MAJOR PROJECT ASSESSMENT: Nepean River Pump and Pipeline

Director-General's
Environmental Assessment Report
Section 75I of the
Environmental Planning and Assessment Act 1979

May 2007

Figure 3: Noise Sensitive Receivers

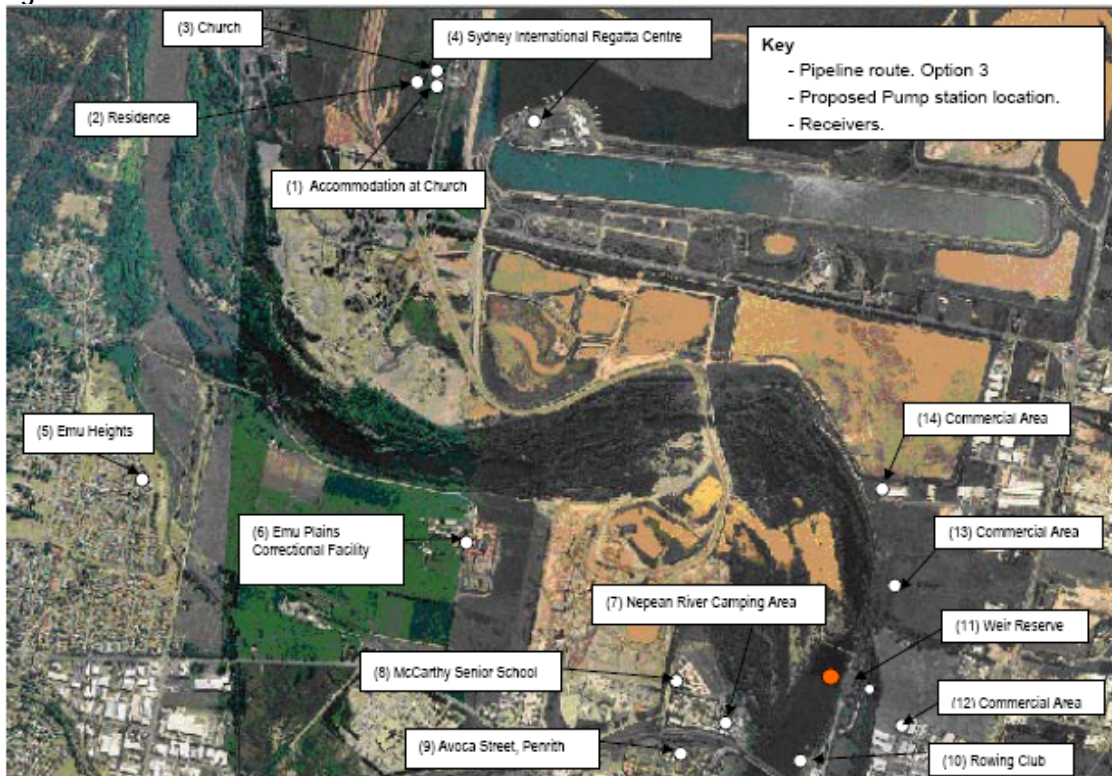
Figure 3 shows the identified noise sensitive receivers in proximity (between 250 m and three km) of the project site, these being an industrial/commercial area, Nepean Rowing Club, Nepean River Caravan Park, Avoca St, McCarthy Senior School, International Regatta Centre, locality of Emu Heights, and Emu Heights Correctional Facility. The nearest of these receivers is Weir Reserve where the pump station and control building would be located.

During construction, the most significant noise would come from construction plant and equipment (excavator, vibratory piling, front end loader and dump truck) which have typical sound power levels of 110 -114 dBA. These will be used for the pump station construction.

- prepare and implement a Construction Noise Management Plan as part of the CEMP;
- provide signage at Weir Reserve two weeks before commencing works to alert users to upcoming disruption;
- notify the local community of construction activities prior to commencing construction;
- maximise the offset distance between noisy plant and equipment, and surrounding noise sensitive receivers;
- operate stationary plant to direct maximum noise emissions away from sensitive receivers; and
- schedule any noise works for less sensitive periods of the day, wherever practicable, particularly around any significant Church events.
